CITY PLAN BOARD STAFF REPORT

PROJECT NAME AND NUMBER: Fueling Station on 13th and 23rd, PB-18-154 SUP

Special Use Permit - Quasi-Judicial

Staff recommends approval of Petition PB-18-154 SUP with

Figure 4: Existing and Proposed Curb Cuts and Cross Access

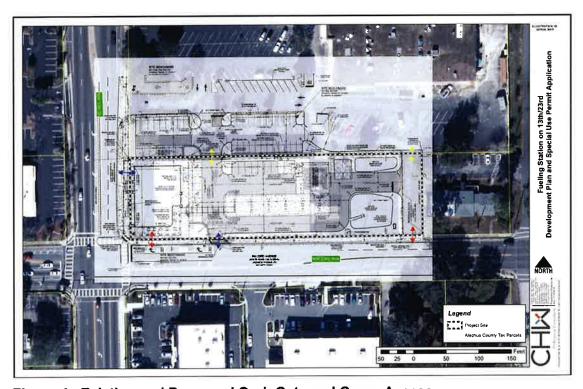
Policy 10.1.4 of the Transportation Mobility Element requires closure of existing excessive, duplicative, or unsafe curb cuts or narrowing of overly wide curb cuts at the development site. The parcel which was the former site of a furniture store has curb cuts which will be eliminated as part of the development plan for the proposed development. On NW 13th Street, a right-in/right-out driveway will be closed (see Figure 2), while an existing right-in/right-out joint access driveway to the north of it will continue to provide access to the fuel station site and the shopping center (see Figure 3).

On NW 23rd Avenue a right-in/right-out driveway close to the intersection with NW 13th Street will be moved approximately 80-90 feet east (see Figure 4). An existing driveway just east of the vacant furniture store will be removed (see Figure 5), while the existing full-access, joint-use driveway on the eastern end of the property will remain (see Figure 6).
